Technical Memorandum

Project: GPC6, C2012668-02 Task Order #39 Dallas

CBD Second Light Rail Alignment

Subject: FINAL DRAFT Technical Memorandum No. 14 – REVIEW

FIGURE 1: TYPICAL LAYOUT of INTERNAL WATER DRAINAGE SYSTEM in STATION

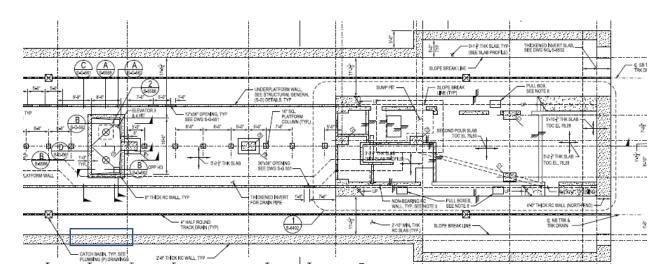
Disposal of water in this category is carried out by means of an undertrack drainage pipe with catch basins placed generally at 100 feet spacing along the low-lying trough. Water thus collected is conveyed by means of transverse pipes to a main pipe running along the center of the structure, as shown in Figure 1. The piping system is completely embedded in the structural slabs and can be adequately maintained or unclogged through the catch basins along the undertrack pipes and cleanout handholes placed along the main center pipe.

Clogging of this system is caused by debris and its maintenance can be performed by common pipe cleanout procedures accessing the system through the provided cleanouts.

FIGURE 2: TYPICAL DETAIL of DRAINAGE TROUGH for INTERNAL WATER DRAINAGE

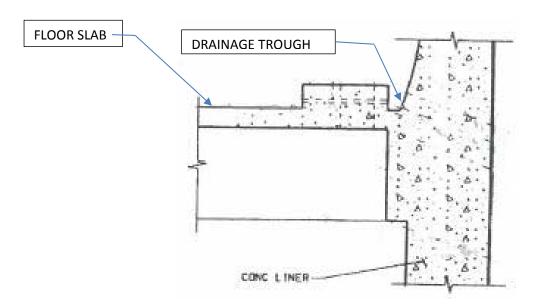
grouting pipes, thus limiting the duration and quantity of water inflow. Nonetheless, it is good practice to convey any seepage water through appropriately located troughs, as shown in **Figure 2**, to the internal drainage system. As the quantity and duration of such flows are small, they would not cause a serious precipitation and clogging of pipes during the design life of the facility, if cleanouts are provided and properly maintained.

(b) At Commerce Street and CBD East Station FIGURE 3: DART D2 SUBWAY PROFILE

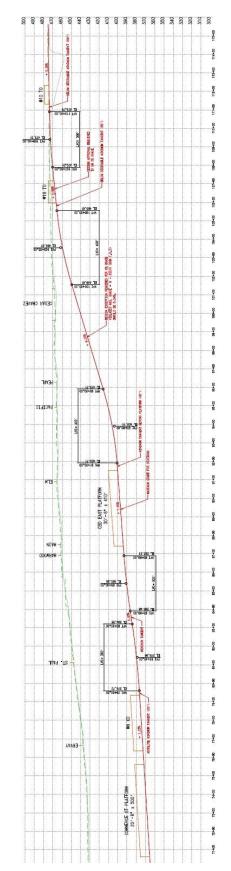
The life-cycle cost assessment should be performed and different (drained or undrained) structures analyzed, after the alignment and related underground structure locations become finalized and agreed upon (usually before 30% design completion). This analysis should account for the current experiences of DART maintenance and operation personnel with the existing system currently installed in DART existing stations and tunnels (Cityplace Station). With the current D2 Subway alignment profile shown in Figure 3 a maximum groundwater head of approximately 56 feet occurs at the Metro Center station, which could be constructed either as a mined cavern or a cut-and-cover station boxes. There, the groundwater head is not excessive, and may not warrant complex drainage system installation, and further continual maintenance costs, to relieve initial capital investment of somewhat heavier structural element installation. However, the final cost-benefit analysis (taking place after the alignment and third-party impacts are finalized) would provide definitive qualitative and quantitative evaluation and include operational and economic assessment of both drained and undrained systems. Only after this analysis the underground stations and tunnel configuration would be finally recommended.

Further, as noted above and illustrated in the figures below, the depth of the stations might not warrant the provision of a groundwater drainage system, and these structures would be fully waterproofed (as noted in the 10% submission of the D2 Tunnel Design, Figures 4 and 5).
